P&Z STAFF REPORT

Board of Appeals Hearing; December 11, 2018

Case: **V18-0027 – 8045 Innsbruck Drive**

Variance from Section 2.2.2 of the Development Code to encroach into the required side setback for the construction of an attached garage.

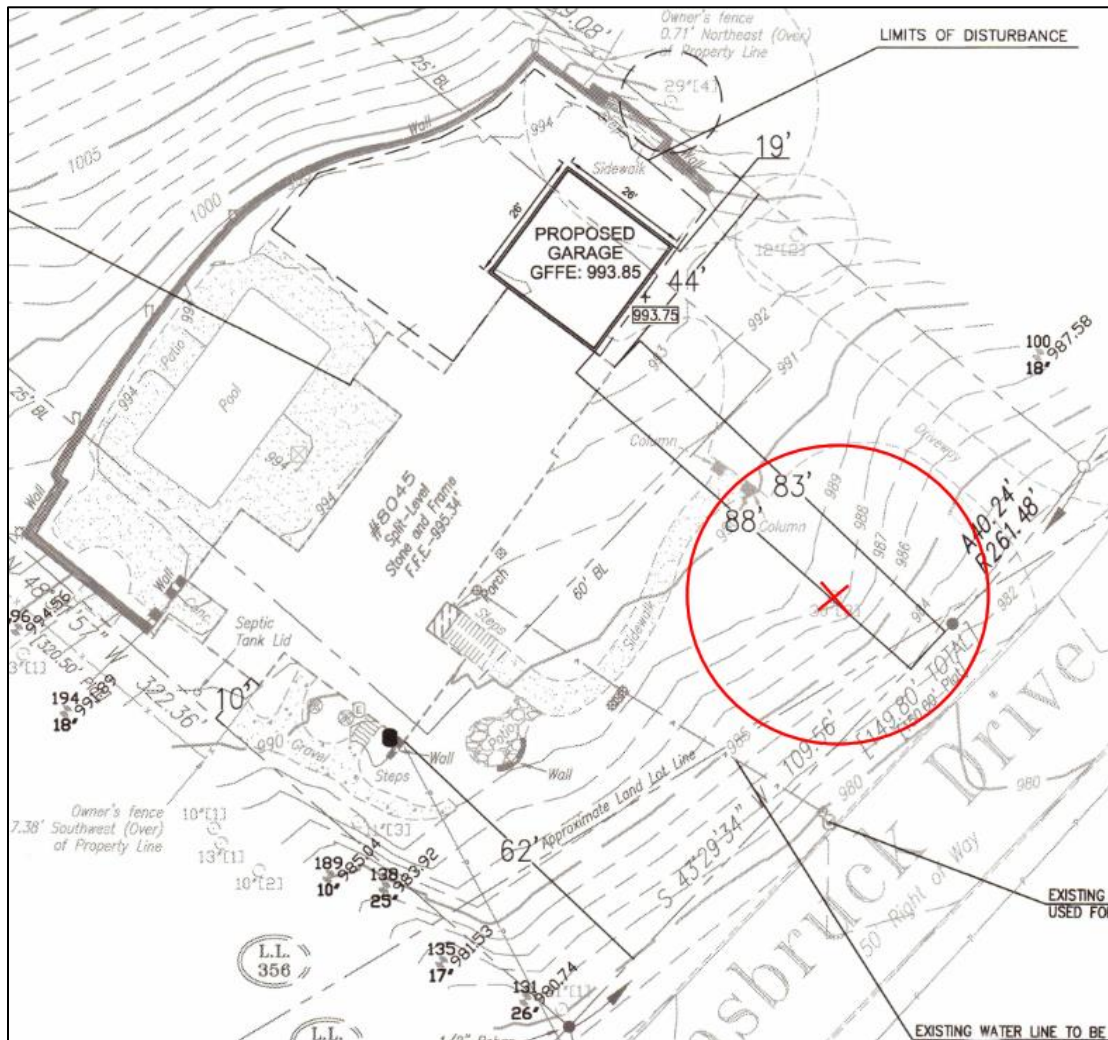
The lot topography is fairly flat until it meets the retaining wall. **In the plan below, please note the buildable in area in yellow. The red line demarcates a 6 foot retaining wall, which bisects the property, cutting the buildable area in half.** Behind the retaining wall is a moderately steep slope (roughly a 15% slope from the top of the wall to the rear property line). Due to the challenging topography, the property owner is extremely limited in potential locations for the proposed garage.

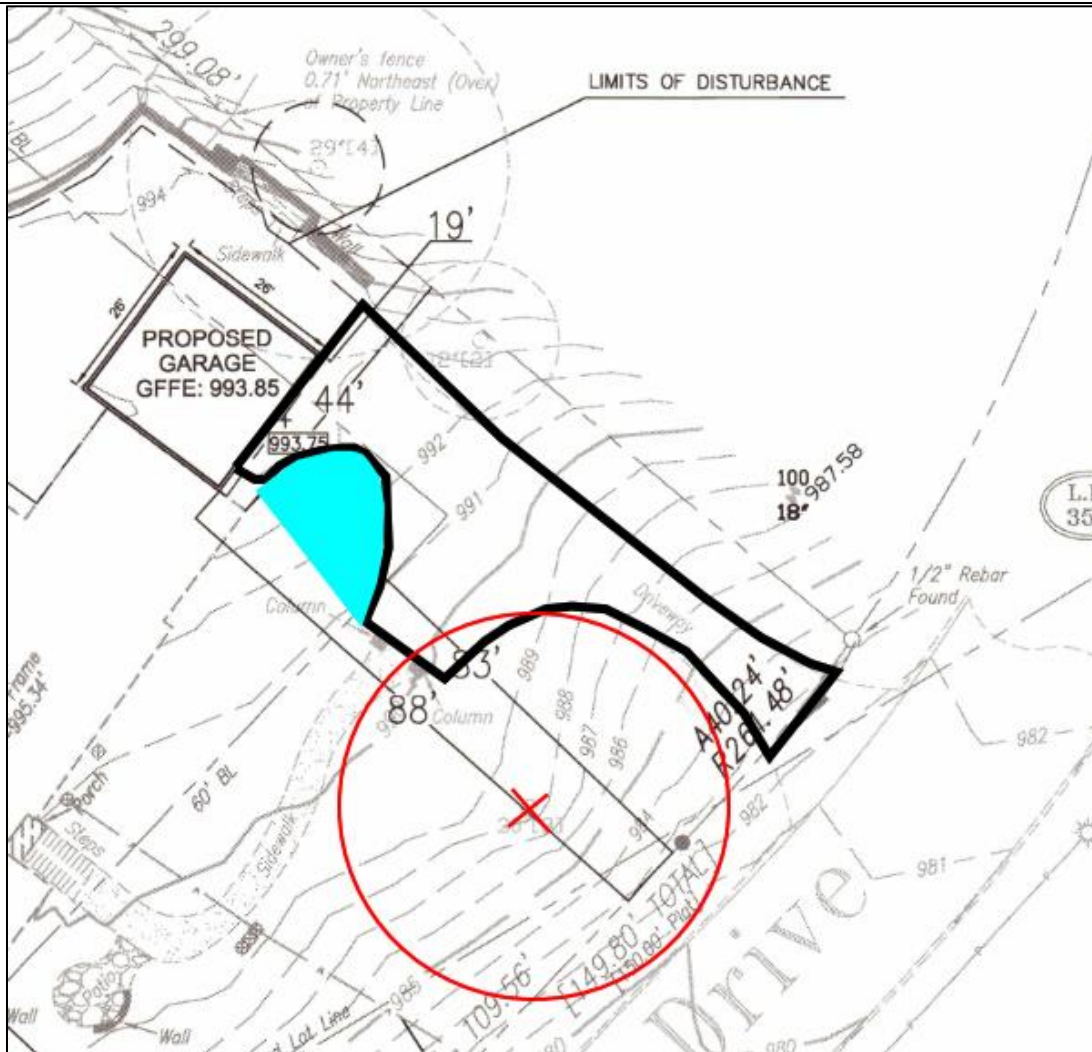
The proposed garage will add 626 square feet of impervious surface back. This is the only impervious surface the applicant is currently proposing, but **staff believes for the proposed garage to be functional, an additional 300 square feet of driveway will need to be added**, the location of which is shown below in blue in the plan below. This addition would not affect the large oak tree in the front yard, as it will not impact the critical root zone of the tree.

The proposed garage and driveway addition will add approximately 926 square feet of impervious back. **The net loss of impervious surface will be approximately 1330 square feet, which is a significant improvement** that will also help alleviate the drainage issues by increasing the amount of pervious surface.

STAFF SURVEY EVALUATION – EXHIBIT B – Site if variances granted (full size in package)

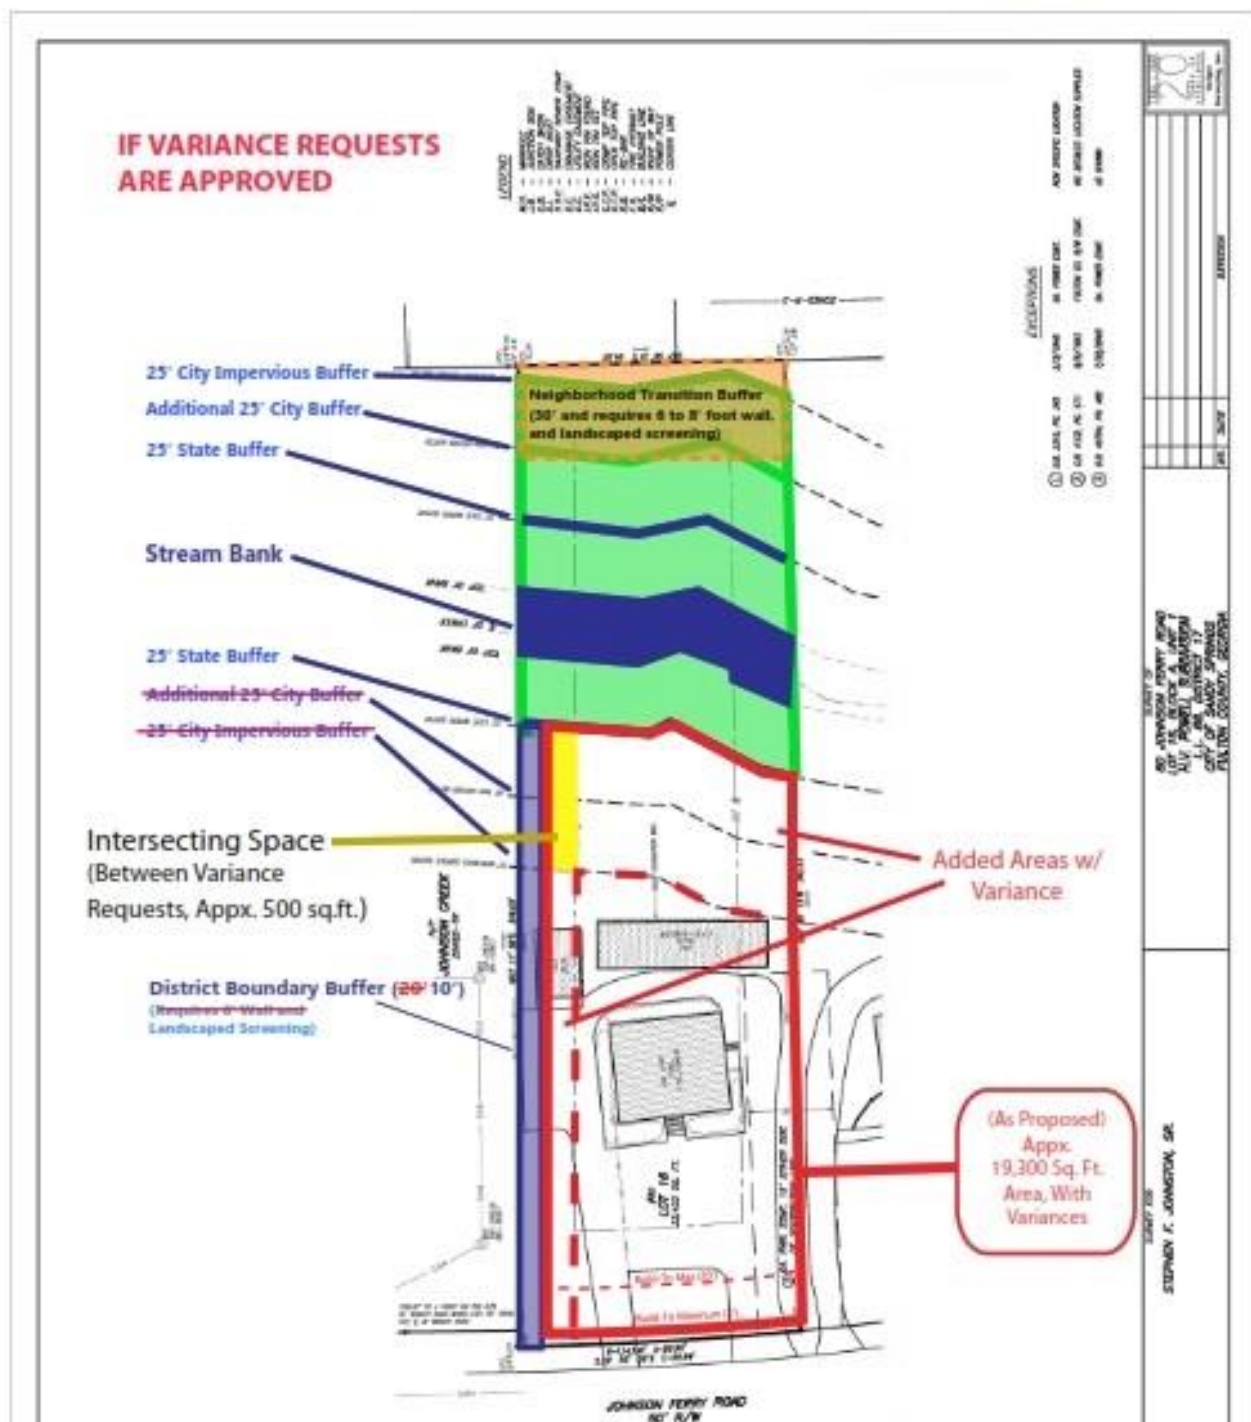
Due to the nature of the very limited amount of information available, Staff estimates that approving this particular Variance would increase the buildable area of the lot by approximately 1,800 square feet as illustrated in “Exhibit B.”

Due to the nature of the very limited amount of information available, Staff estimates that approving this particular Variance would increase the buildable area of the lot by approximately 4,000 square feet, as illustrated in “Exhibit B.”
